DEVIATION REVIEW AND DECISION FORM

Subdivision or Project Name: **Springs East at Waterview, preliminary plan**

Section of ECM from Which Deviation is Sought: 2.3.7.D.1 Intersections, Turn Lanes Required

Figure 4

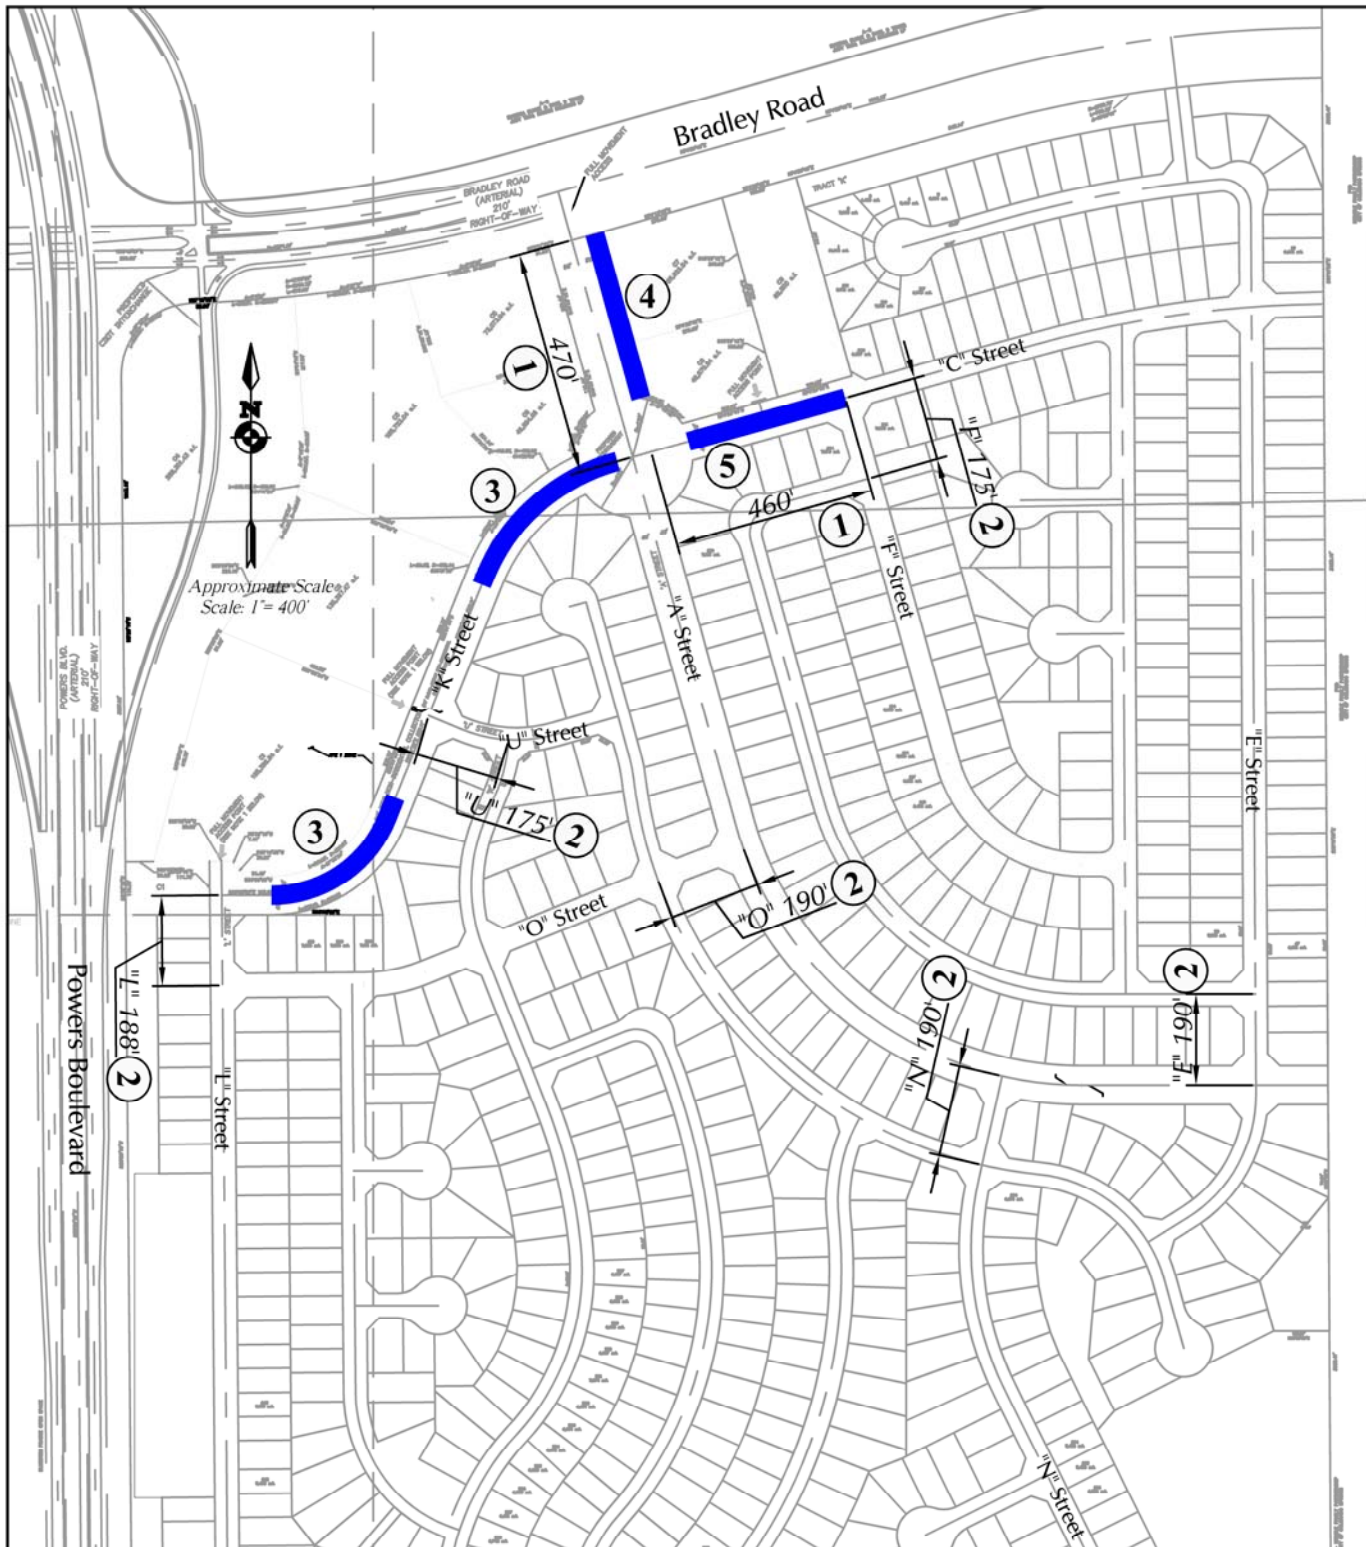
Proposed Nature and Extent of Deviation: On the northbound approach at the intersection of Bradley Road and "A Street:" The request is to allow a left-turn lane and taper lengths shorter than the ECM standard. The request is to allow the turn lane to consist of adequate storage distance in the proposed dual left-turn lanes, but not include the full-length deceleration distance (as prescribed in the ECM). The northbound approach at the A Street/Bradley Road intersection will likely be Stop-sign controlled, initially, and future change to traffic signal control is proposed. Given that most of the signal green time would be assigned to eastbound/westbound Bradley Road, the northbound approach will be an expected "stop condition" for drivers exiting the subdivision or the commercial. Drivers will negotiate the roundabout to the south at a design speed lower than the standard design speed for a non-residential collector. After negotiating the roundabout, drivers will expect a stop condition at Bradley Road. Also, most of the approach turning movements will be right turns or left turns onto Bradley Road (prior to the development on the north side of Bradley, all vehicles will turn left or right). Given these site-specific conditions, the request to waive the requirement for deceleration distance is reasonable. Also, the request is to allow a custom lane transition taper for the entry into the dual left-turn lanes. This taper will be a reverse-curve bay taper design that will be integrated with the splitter island design of the roundabout. The intent will be to create an appropriate transition for motorists entering the left-turn lanes -- with curvature and an appropriate overall length -- while maximizing the full-width dual left-turn lane length for stacking of left turning vehicles approaching Bradley Road.

Comparison of Proposed Deviation to ECM Standard: Please refer to the attached Deviation Table 1. The ECM standard for a 40-mph design speed limit is 155 feet of full-width lane plus a 160-foot taper plus storage distance. Regarding storage distance, ECM Table 2-30 calls for 250 feet or more of storage for the Stop-sign-controlled intersections; however, the northbound left turn is at a planned future signal-controlled intersection. The projected queue length from the TIS is more appropriate for determining the queue storage needed for this left-turn lane than the general ECM Table 2-30. The projected maximum queue length from the TIS is 204 feet. LSC recommends an approximately 220-foot dual left lane plus 90-foot reverse curve taper. This is about 160 feet less than the ECM standard.

This request has been determined to have met the criteria for approval. A deviation from Section 2.3.7.D1 of ECM is hereby granted based on the justification provided. Comments:

The exact length and transition point of the lane and taper shall be determined through the construction document review process and shall be maximized to the greatest extent possible.

Appropriate sign requirements will be determined at the construction document stage, and shall meet MUTCD standards.

Approval of this deviation is limited to the layout as shown in this preliminary plan. Any changes to this layout or zoning shall void this approval.
